134-150 S Blair

Certificate of Appropriateness & Variance

April 15, 2024

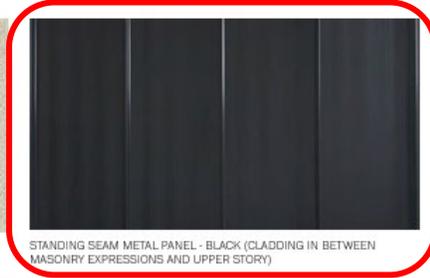
(7) Building Systems **[need info on mechanicals]**

Staff believes that the standards for granting a Certificate of Appropriateness could be met and recommends that the Landmarks Commission refer the proposal to a future meeting with specific guidance on how to meet the standards of approval, with the following recommended conditions of approval:

1. Redesign the front façade of the building to utilize a single architectural vocabulary and only use masonry cladding on the front façade
2. Final door, window, and railing specifications either be administratively approved by staff or included in an updated submittal
3. Information on mechanicals and utility locations on the building either be administratively approved by staff or included in an updated submittal
